RE: PCN # ESU270-80 – SOT23-5L/6L additional backend location approval

PCN# : ESU270-80 Date: July 29 th , 2022 Product Identification : SOT23-5L/6L additional backend location approval Implementation Date for Change: Oct 29 th , 2022 or sooner	Contact Information Name: Sophia Hu Title: Assistant Product Manager Phone # : +86 13771377277 Fax# : N/A E-mail : shu@littelfuse.com
Category of Change: <input type="checkbox"/> Assembly Process <input type="checkbox"/> Data Sheet <input type="checkbox"/> Technology <input type="checkbox"/> Discontinuance/Obsolescence <input type="checkbox"/> Equipment <input checked="" type="checkbox"/> Manufacturing Site <input checked="" type="checkbox"/> Raw Material <input type="checkbox"/> Testing <input type="checkbox"/> Fabrication Process <input type="checkbox"/> Other: _____	Description of Change: Approve additional backend assembly, test, and packing location for SOT23-5L/6L. There are no changes to fit, form & function of the finished products.

Prepared By : Jordan Hsieh-Product Engineering Manager,
 Raider Chen-Product Engineer, Sophia Hu- Assistant Product Manager
Date : 2022/7/20
Device : SP3019-04HTG/SP0504SHTG/SP0504SHTG-ER/SP0504BAHTG/SP

5.0 Physical Differences/Changes:

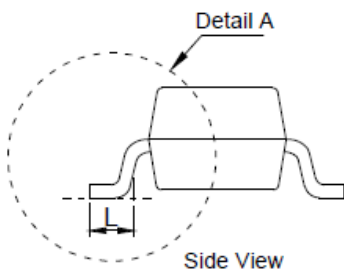
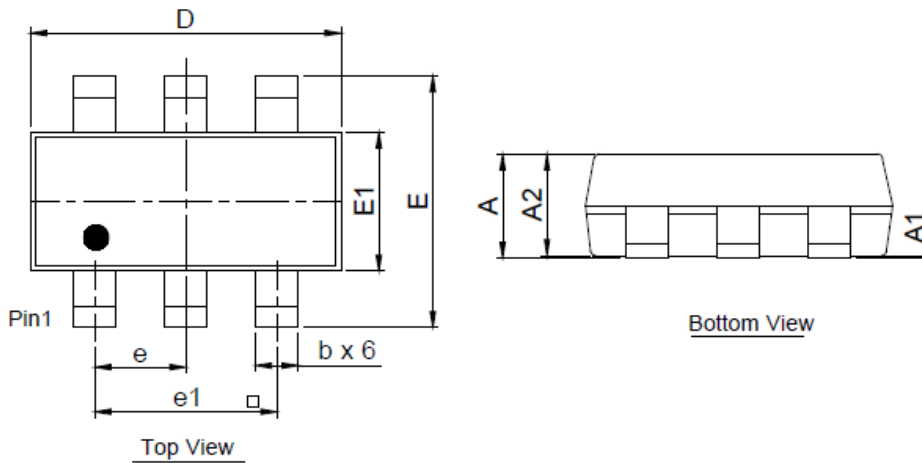
Symbol	Original			New		
	MIN	TYP	MAX	MIN	TYP	MAX
A	--	--	1.45	--	--	1.45
A1	0.000	--	0.15	0.000	--	0.15
A2	0.90	1.15	1.30	0.90	--	1.30
b	0.30	--	0.50	0.25	--	0.50
D	2.75	2.90	3.05	2.70	--	3.05
E	2.60	2.80	3.00	2.60	--	3.00
E1	1.45	1.60	1.75	1.45	--	1.75
e	0.95 BSC			0.95 BSC		
e1	1.9 BSC			1.9 BSC		
L	0.30	0.50	0.60	0.30	--	0.55
